REVIEW OF WATERFORD III BASEMAT ANALYSIS

Structural Analysis Division
Department of Nuclear Energy
Brookhaven National Laboratory
Upton, NY 11973

July 18, 1984

Fig. 1 Location of Elements Listed in Table 1.

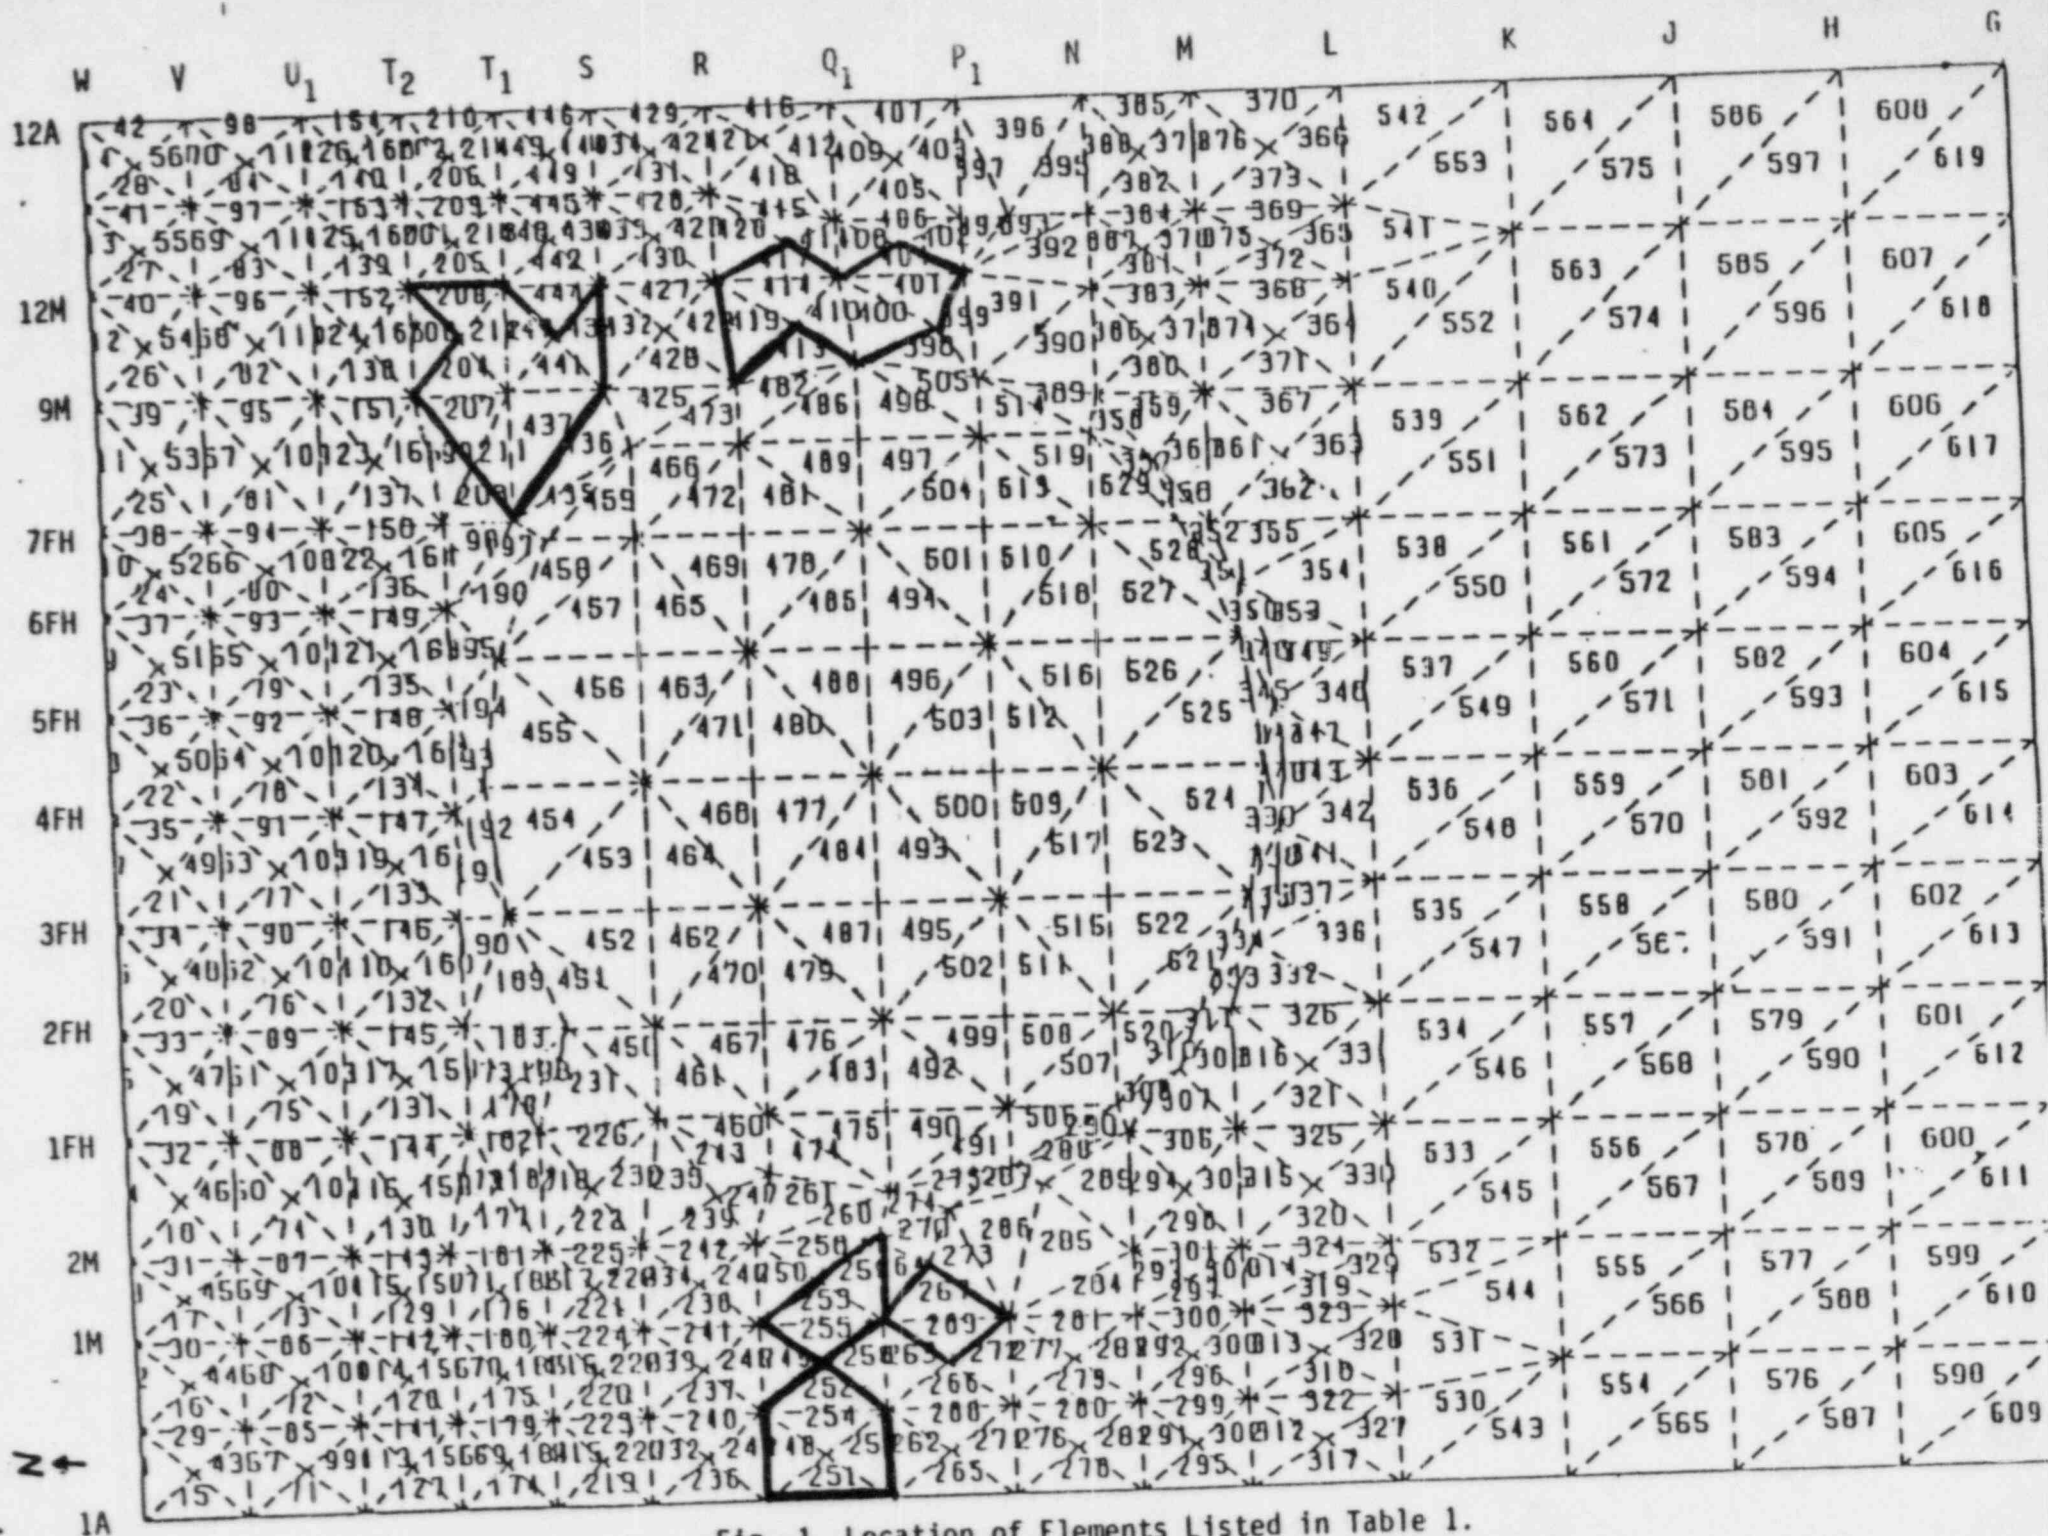
As mentioned, EBASCO in its discussion, and HEA in its reports, have not shown analytically the cause of the top surface cracks. In reviewing the HEA computer outputs, it was found that element moments and shears for individual loadings are explicitly given. These individual loadings are factored together at the end of the computation to provide the overall combined loading calculations. Since individual loading conditions were explicitly given, BNL extracted certain information from these computer runs to provide an assessment of the contribution of the various loading conditions to calculated stresses. Thus, for the case involving dead loads only, a number of elements in the regions where the principal surface cracks appear exhibit moments (positive in sign) that can produce tension and thus create cracking on the top surface. This situation is shown in Table 1 which gives moment data (M_x , M_y and M_{xy}) for elements under various load conditions (dead (D), buoyancy (B) and normal side pressure) in the regions which generally correspond to the areas where the principal surface cracks appear (compare Fig. 1 to Fig. 2).

on the top surface of the mat. While this analysis admittedly is conservative, it supports the previous conclusion that cracking could have occurred during construction due to tensile bending stresses in the top of the mat. Similar results would be found at the other cracked sections shown shaded in Fig. 1.

The additional east-west direction top reinforcements will also cause prevailing cracks in elements located outside the shield wall circle, directly east and west to the shield wall (i.e., those shown shaded in Fig. 1 in areas R-P-2M-1A and R-P1-12A-9M) to be oriented in an east-west direction. This is indeed the pattern indicated in Fig. 2. In contrast, since there is no additional top reinforcement in the elements shown shaded in Fig. 1 located between sections T2-R-12M-7FH (in the northeast sector of the mat), the prevailing cracks do not necessarily have to be oriented in the east-west direction.

In response to a request by the NRC Staff, EBASCO provided an estimate of peak diagonal tensile stress in a region bounded by column lines 9M-I2M-R-Q1 (Figure 1). EBASCO indicated that the average diagonal tensile stress, for the SSE case, in elements 410, 413, 414 and 419 was 210 kips/ft, as compared to a capacity of 274 kips/ft. A meeting was held at EBASCO on July 2, 1984 to review these data. The following conclusions were reached at that meeting:

Fig. 2 CRACK MAPPING PER
RR/GW 8-31-83 TO 9-2-83
FOR HEA, INC (ADB)

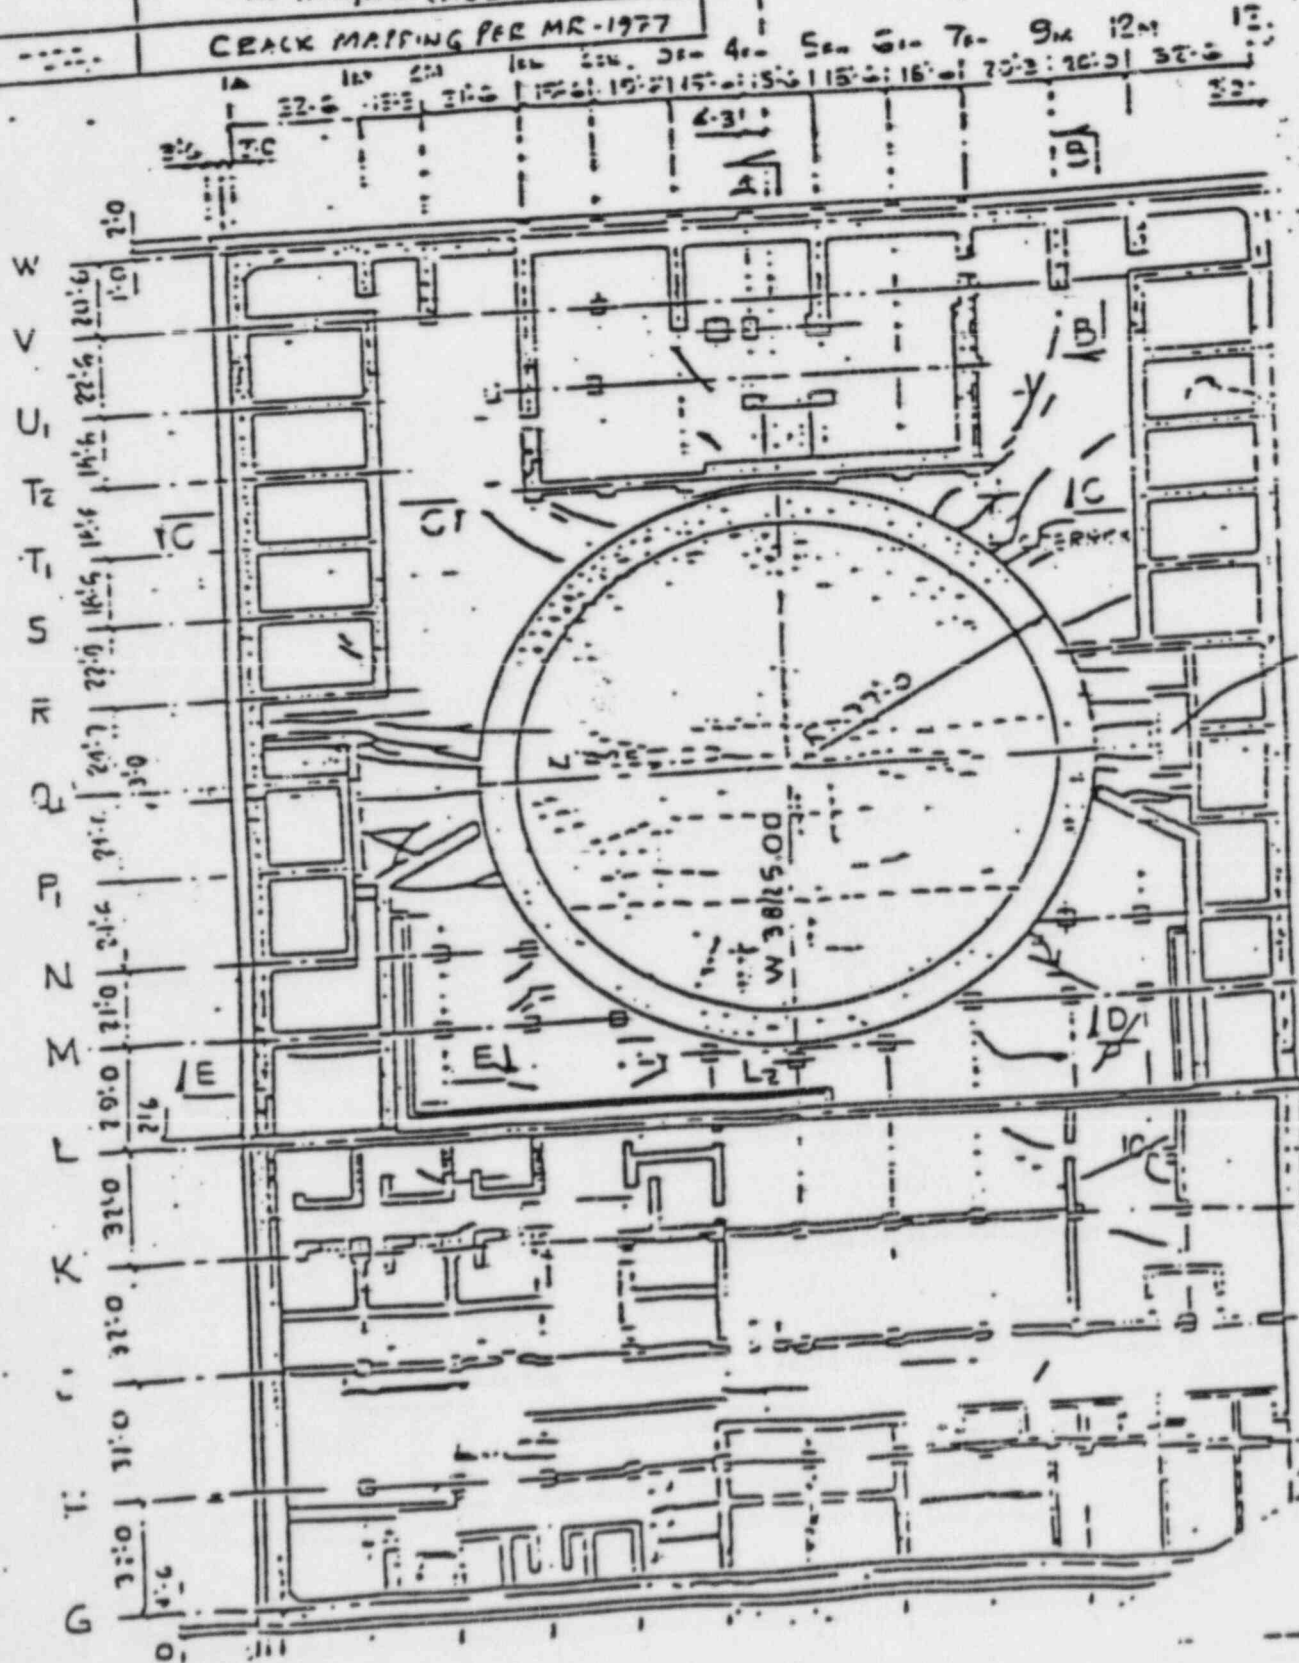
Returning to the data shown in Table 1, it is to be noted that the moments in several elements exceed the working stress capacity. For example, for element 208, the dead load (D) moments M_x and M_y are respectively equal to 350 and 895 kip-ft/ft and are positive. Thus, as mentioned previously, the top surface of the mat in this area is in tension. The maximum principal moment is a function of M_x , M_y , and M_{xy} and its computed value is close to 1000 kip-ft/ft. This moment exceeds the working stress capacity and thus would be expected to expand any existing shrinkage and thermal cracks in this element. Similarly, any such pre-existing concrete cracks would become more significant under the dead load condition in other elements located in the three areas where major cracking in the basemat outside the shield wall was observed, i.e., elements 447, 212, 204, 253, 255, 269, 257, 417, and 404 (see Figure 2).

As shown in Fig. 2, crack patterns were also noted in March 1977, internal to the shield wall. At that time, based on information provided by EBASCO, the shield wall was partially constructed up to elevation 187' and the steel containment was supported on temporary footings. Other walls or structures on the mat either were not yet constructed or were only partially constructed. Since the computer dead load calculations refer to the mat with all existing structures, which of course has different dead weight loads and different spatial distribution of these loads than the partially completed case (for example, the massive concrete fill on which the containment rests, plus all equipment in containment, would not be included in a model of the 1977 configuration), it is not possible to utilize the HEA computer results to explain the

Fig. 3 MAT REINFORCEMENT

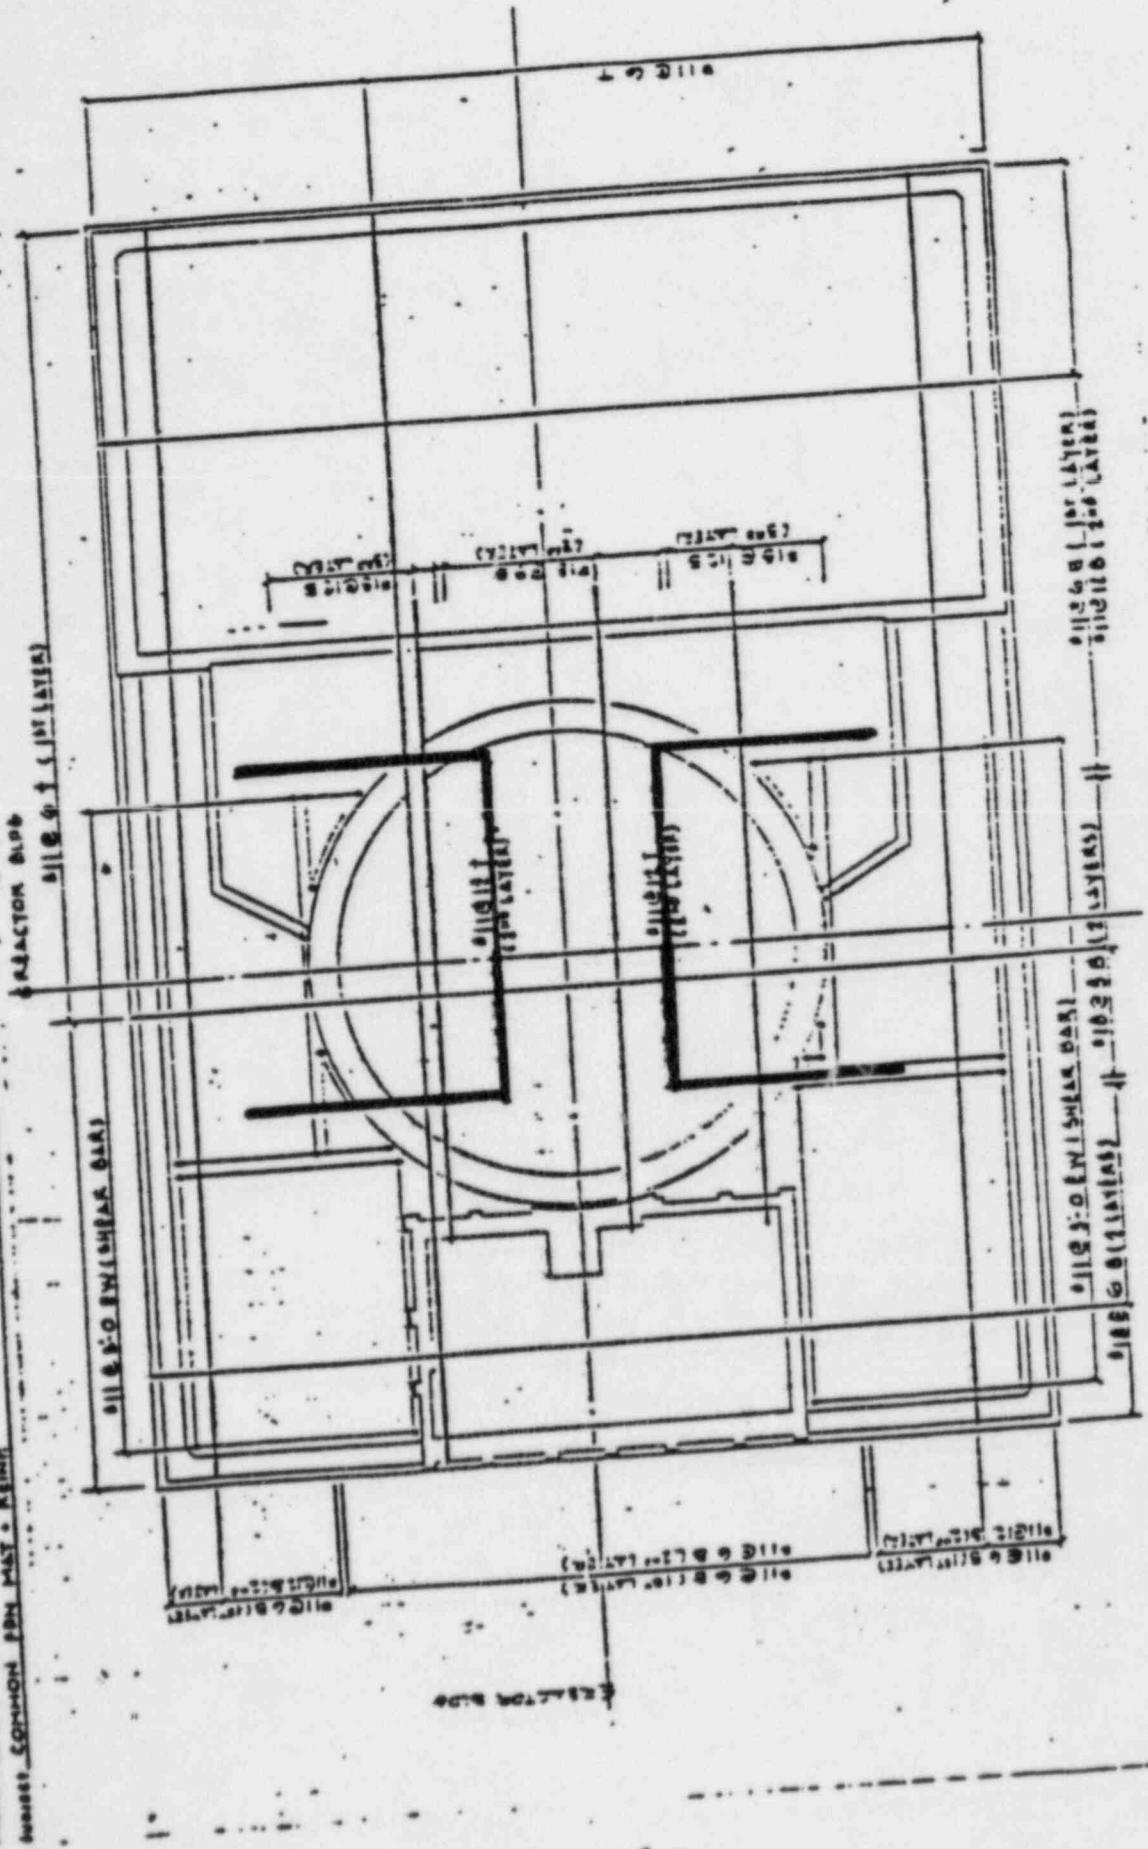
Prior to discussing the results shown in Table 1, it is necessary to consider the strength characteristics of the base mat. In particular, the bending moments causing tensile stresses in the top of the mat are of interest. As may be seen from Figure 3, all of the north-south reinforcement for the top of the mat consists of No. 11 bars placed six inches on center (#11 @ 6"). The top east-west reinforcement is also #11 @ 6" except in the vicinity of the containment where #11 @ 12" are added.

1977 cracks. It is noted, however, that the additional top reinforcements (i.e., # 11 @ 12" as shown in Fig. 3) are essentially located in areas under the shield wall and are placed in an east-west direction. Thus, if cracking should occur, the preferred direction would be parallel to the direction of the heavier reinforcement, or east-west in orientation. This is indeed the direction of the cracks, and these cracks, in all likelihood, had the same origins as the cracks outside the shield wall (dead loads acting in conjunction with thermal and shrinkage effects).
